Global Wulfsberg *Service Bulletin*

BULLETIN NO: C-5000-4
C-5000 Communications Management
Controller

To improve Digitally Coded Squelch (DCS) tone operation during Transmit.

This modification consists of adding a capacitor to the Tone Module.

Figure 1
 C-5000 Tone Module
 300-018390 Rev-4

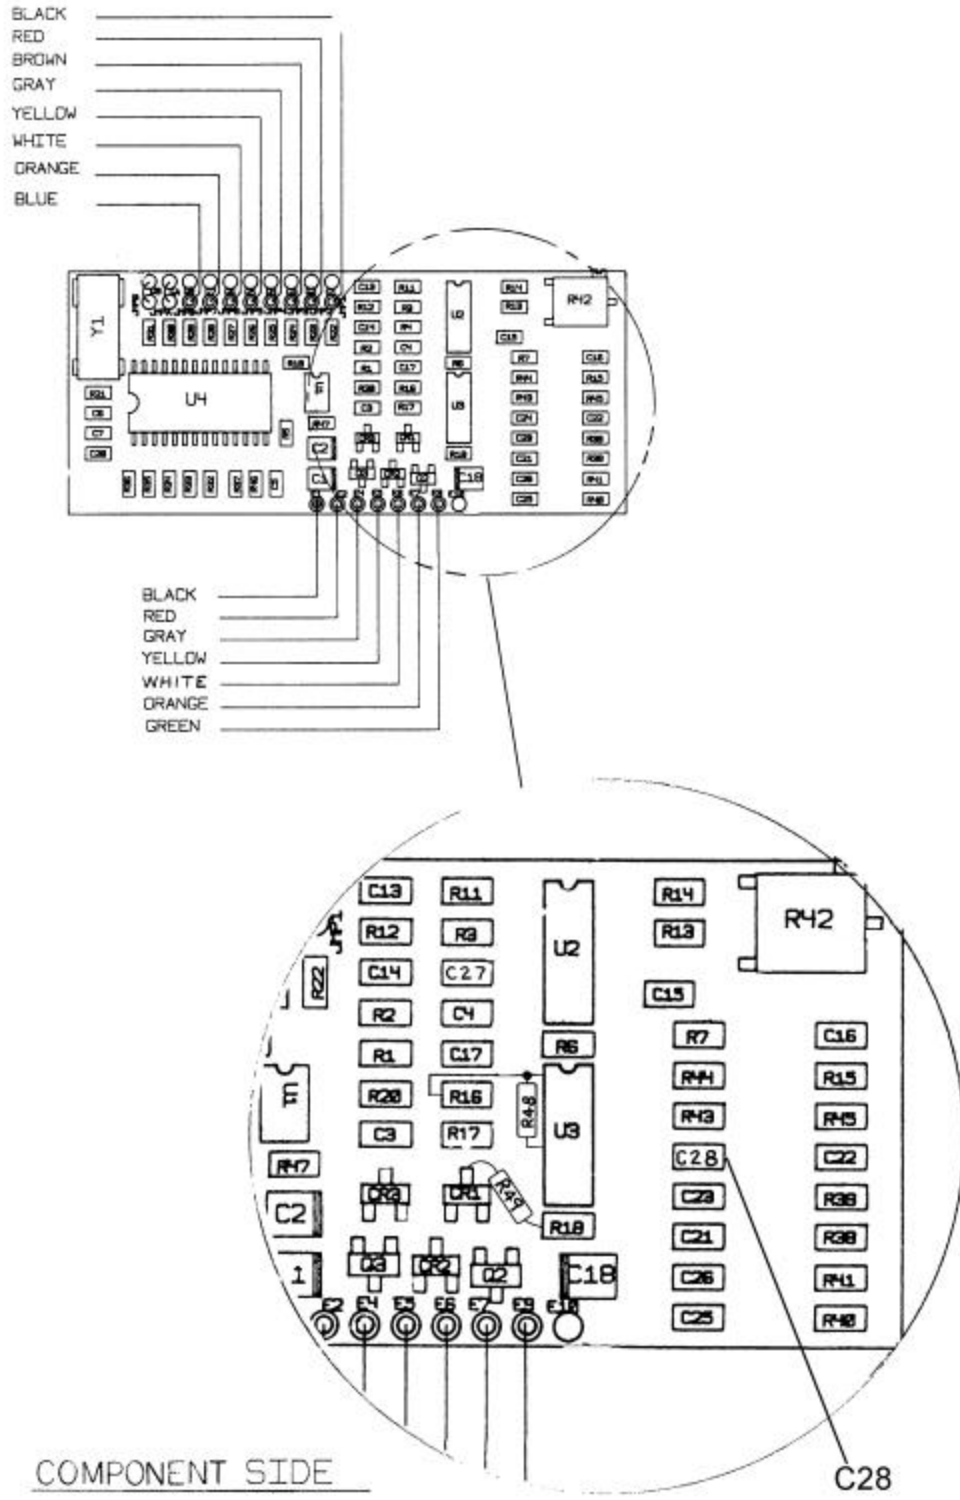
2. See Figure 1. Add C28, P/N 096-01186-0080, on top of C24, with the positive side toward C22.
3. Reassemble the unit.
